DICK VAN DYKE ADDICTION TREATMENT CENTER – KITCHEN & DINING ROOM ADDITION INCLUDING ASBESTOS ABATEMENT PROJECT

ADDENDUM # 003

Date Issued: September 30, 2026

1 FIRST FLOOR SANITARY & VENT PIPING PLAN
SCALE : 3/16" = 1'-0"

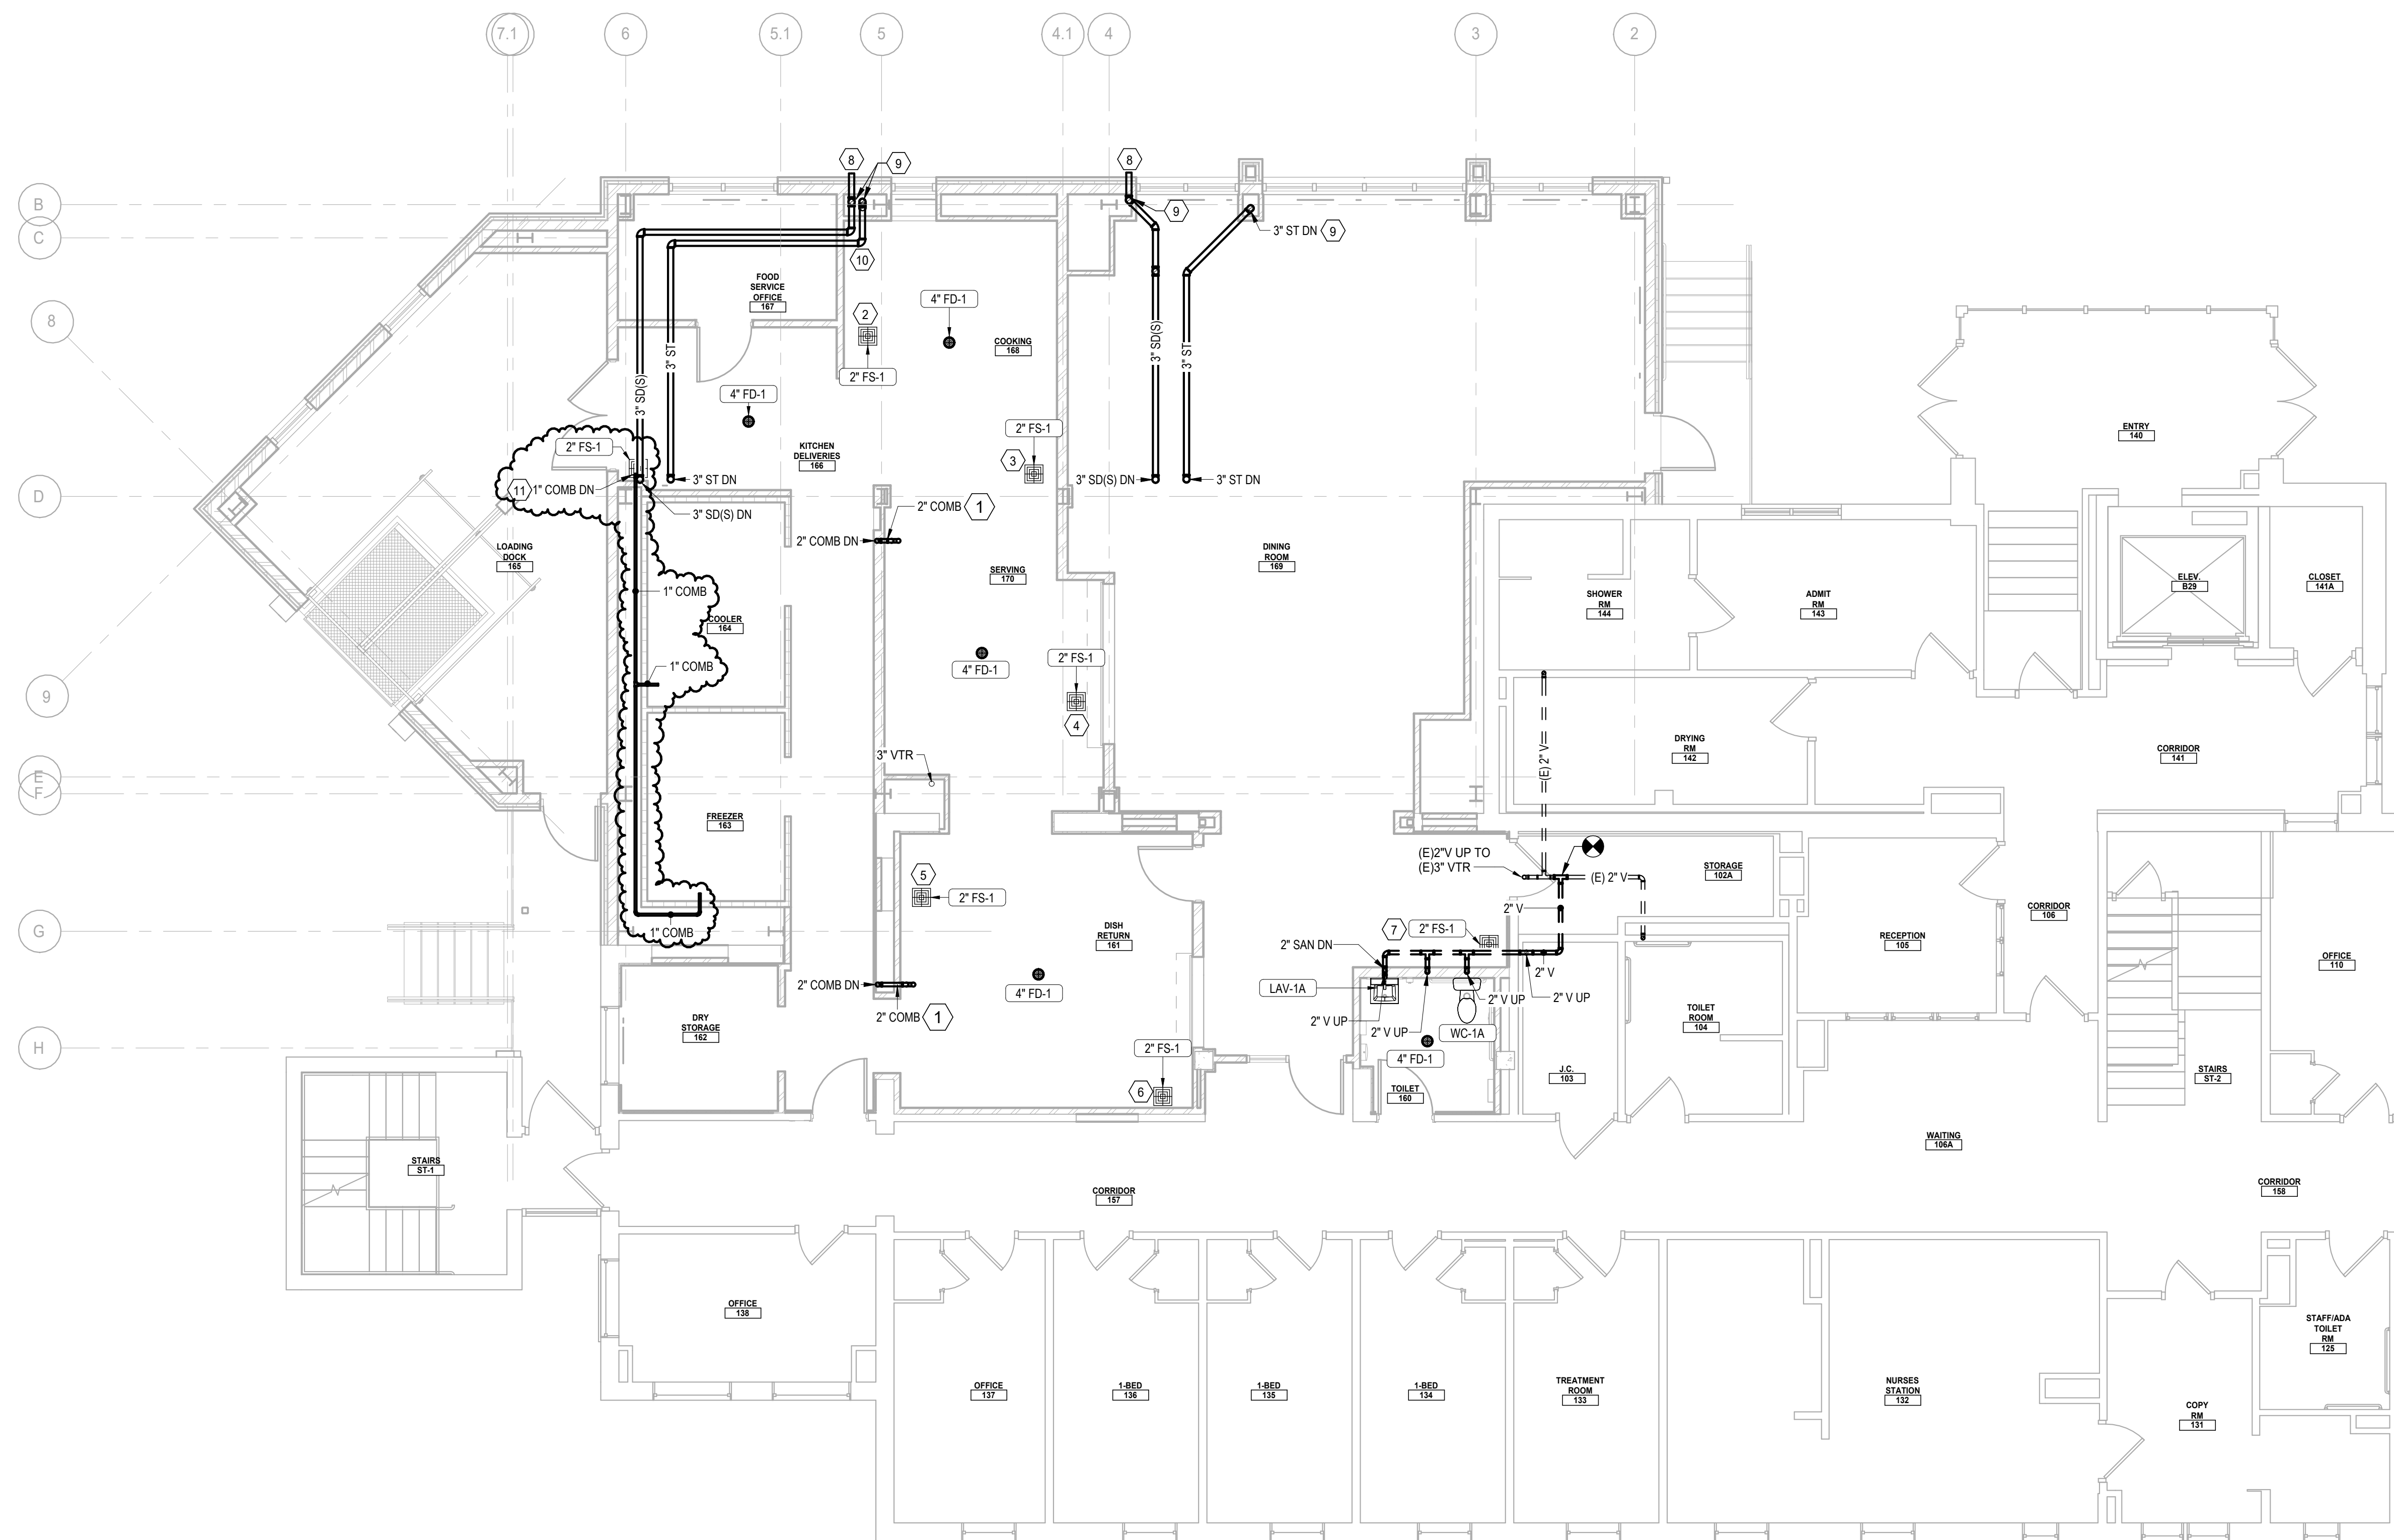
1. Please provide a spec section for louver L-1 and L-2 that can be found on M101 and in the schedule on M600.
 - **RESPONSE:** Contractor to buy the model and submit comparable products as shown on M101 and M600 drawings.
2. FSE-2 Kitchen plumbing plan, items no. 9.1 and 9.3 evaporator drains. Where are these to drain?
 - **RESPONSE:** See drawings P100 and P101 issued as part of Bid Addendum #003.

1 BASEMENT FIRE ALARM PLAN

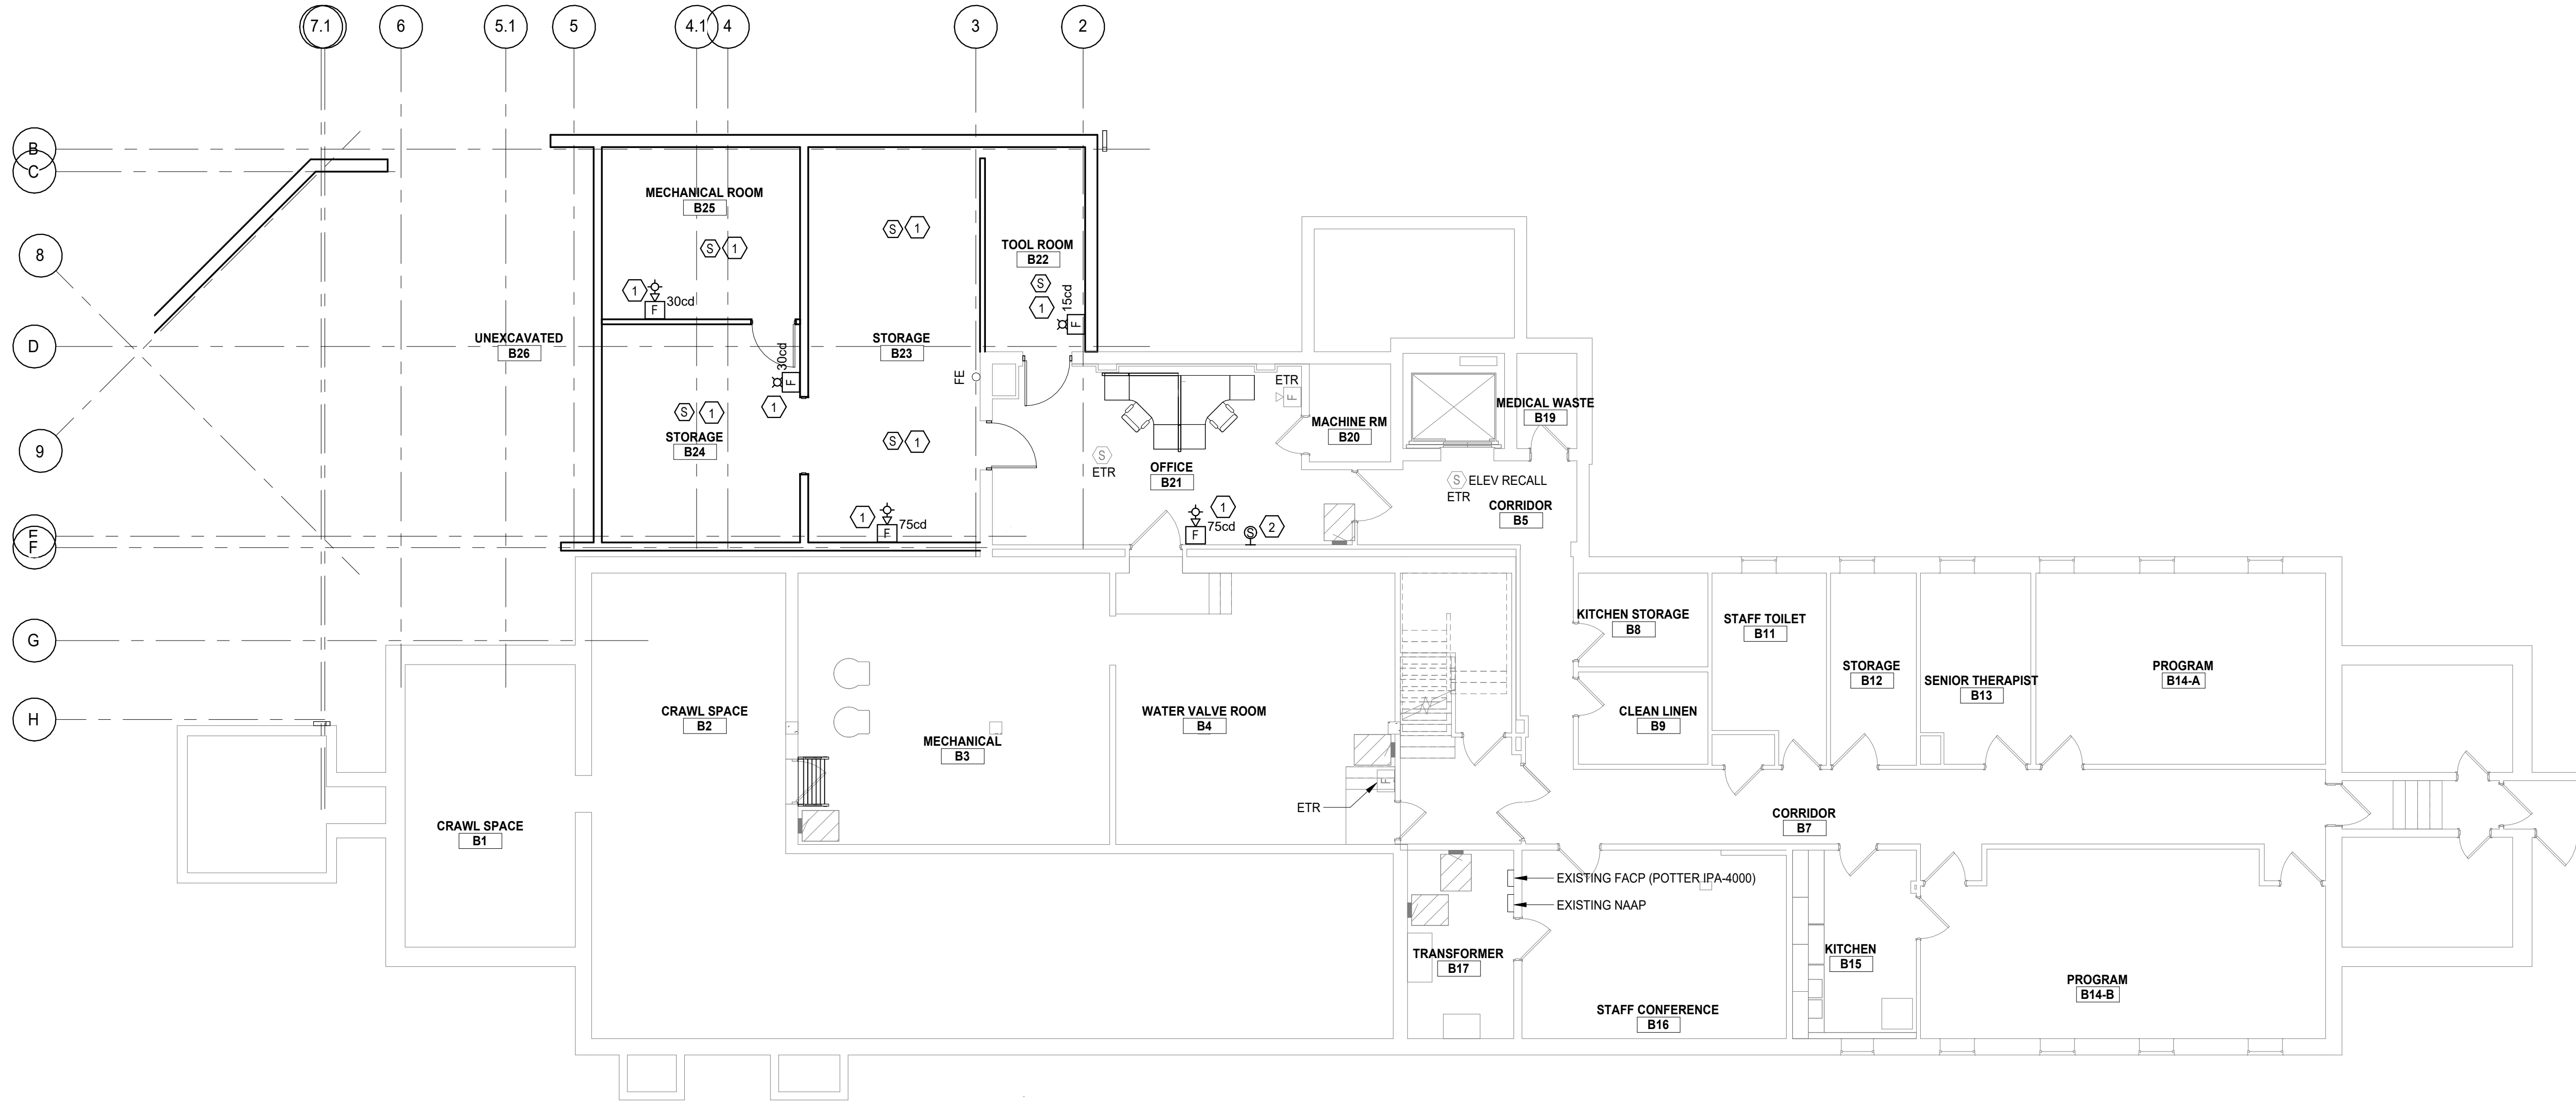
1. We are preparing a bid for the Dick Van Dyke ATC Kitchen & Dining Room Addition. The specs require the new fire alarm work to match and extend the existing system. However, the documents don't identify the existing service vendor. Can you share the name or contact information of the fire alarm vendor who currently services the facility.
 - **RESPONSE:** Specification 284621.11, section 2.1 – Addressable Fire – Alarm Systems and sheets E300 and E301 have been modified to include basis of design.

1. PROVIDE FIRE ALARM DEVICE COMPATIBLE WITH EXISTING SYSTEM.
CONNECT TO EXISTING FACP ON THIS FLOOR. PROVIDE ALL
PROGRAMMING AND TESTING.
2. PROVIDE SPEAKER COMPATIBLE WITH EXISTING BUILDING SYSTEM.
PROVIDE CONDUIT AND WIRING TO HEADEND. COORDINATE WITH
OWNER ON LOCATION OF HEADEND. BASIS OF DESIGN IS VALCOM.
